List of Commenters

SUBJECT: Bicycle Master Plan – MCDOT Public Hearing Comments

Figure 4. East County Bike Plan Neighborhood Bikeway Suggestions

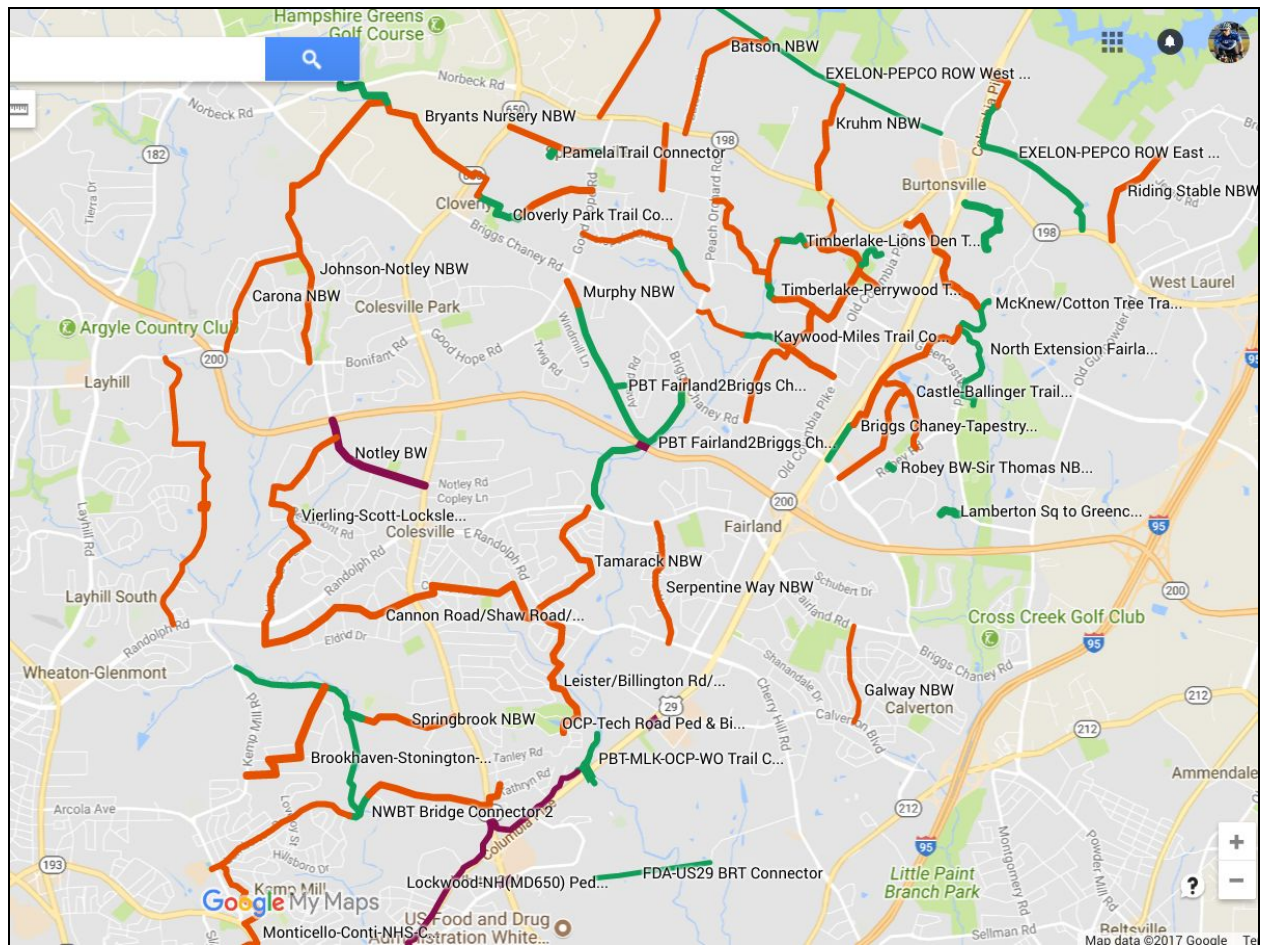
Figures 4. and 5. provide thumbnails of detailed graphical depictions of our recommended bicycle infrastructure to be included in the Montgomery County Bicycle Master Plan. We encourage your team to review the detailed recommendations that we have catalogued in the following media:

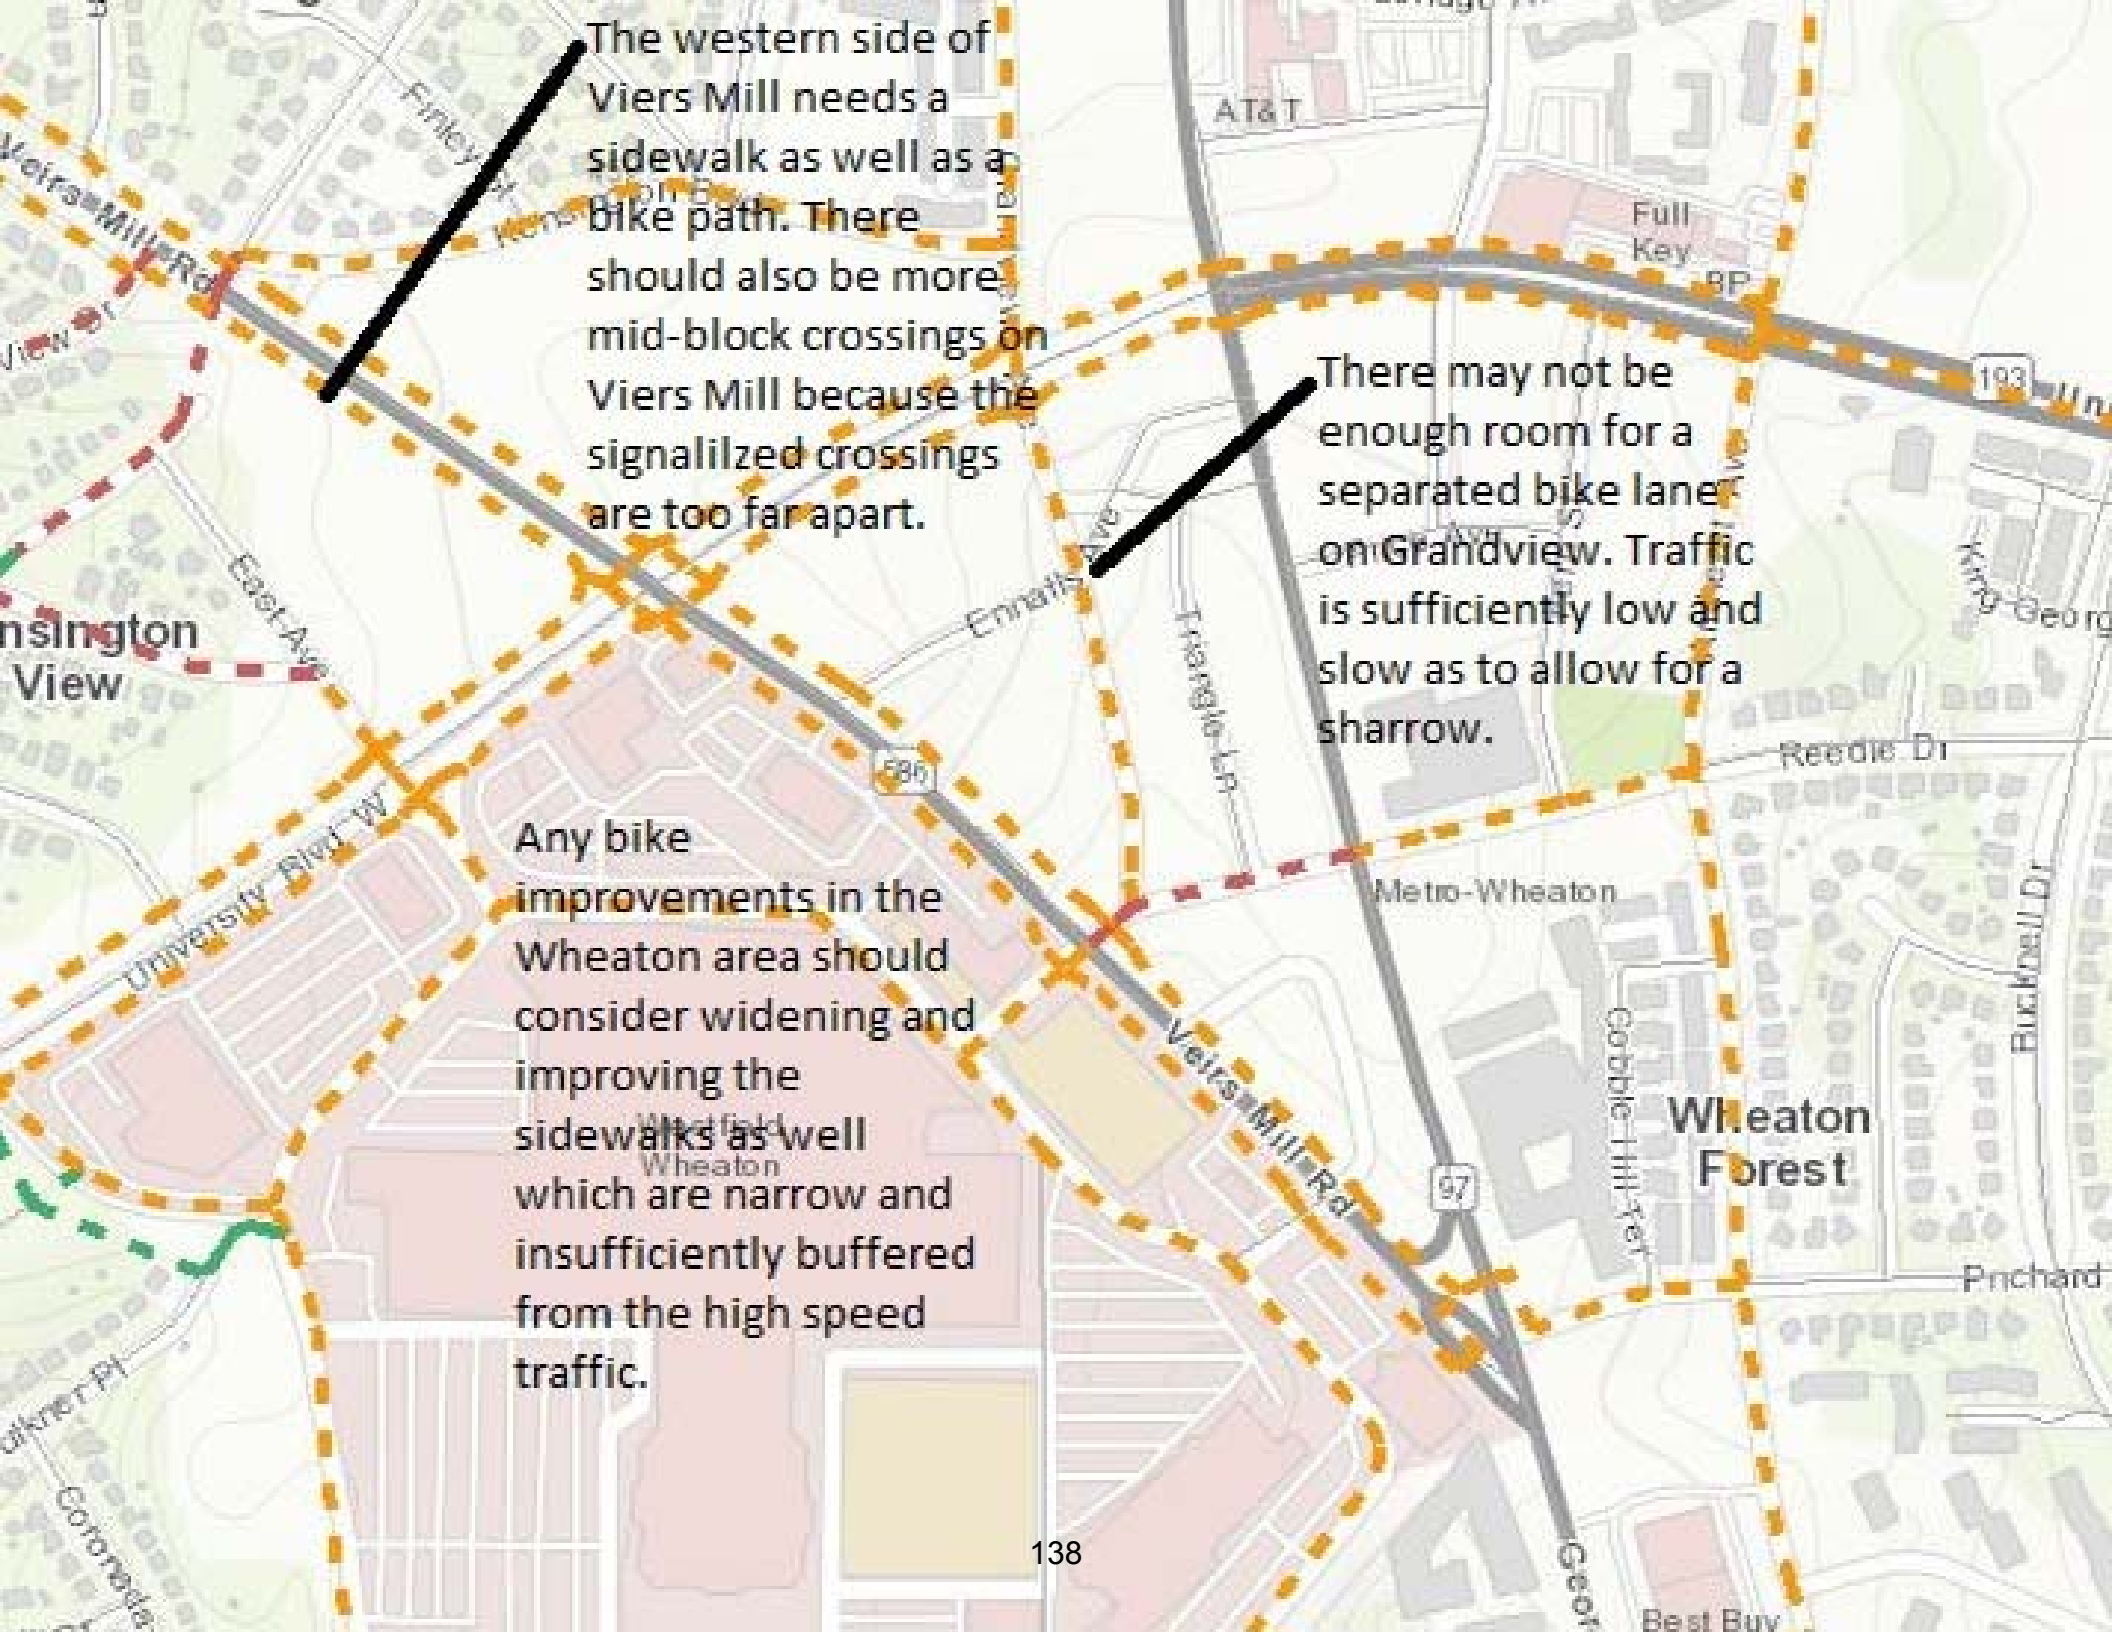
Remove this connection. Grade is too steep.

The western side of Viers Mill needs a sidewalk as well as a bike path. There should also be more mid-block crossings on Viers Mill because the signalized crossings are too far apart.

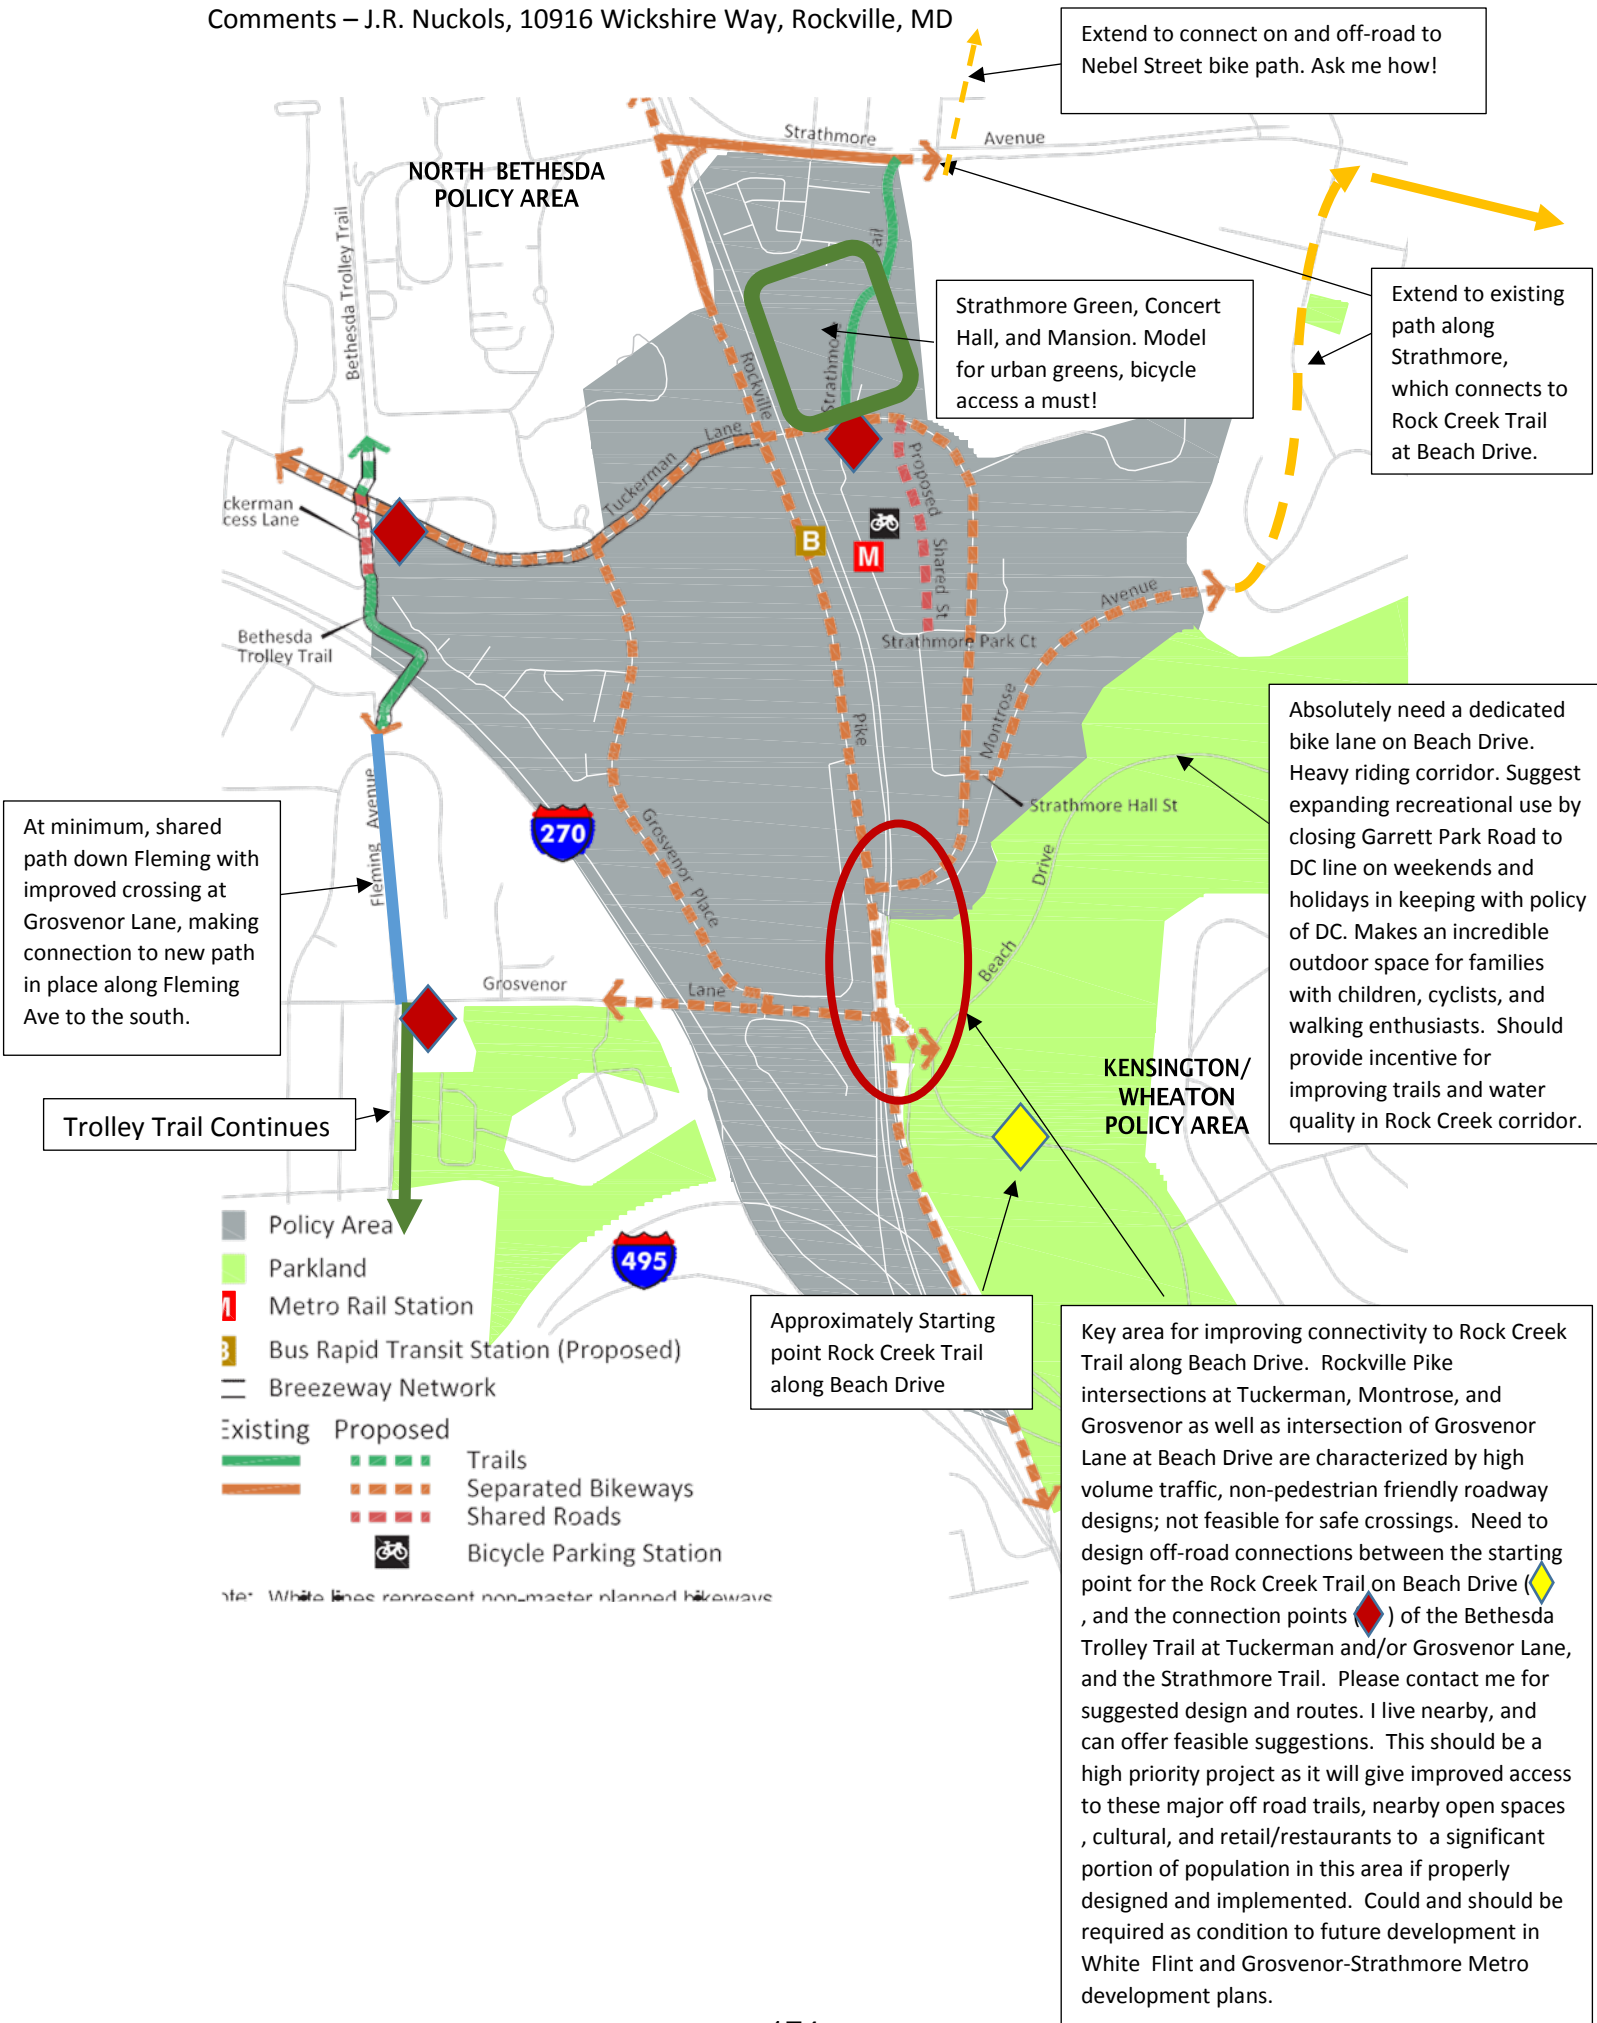
Attached please find my specific recommendations for improving the plan towards the above goals in the Grosvenor Planning Area (P. 290) in the report.
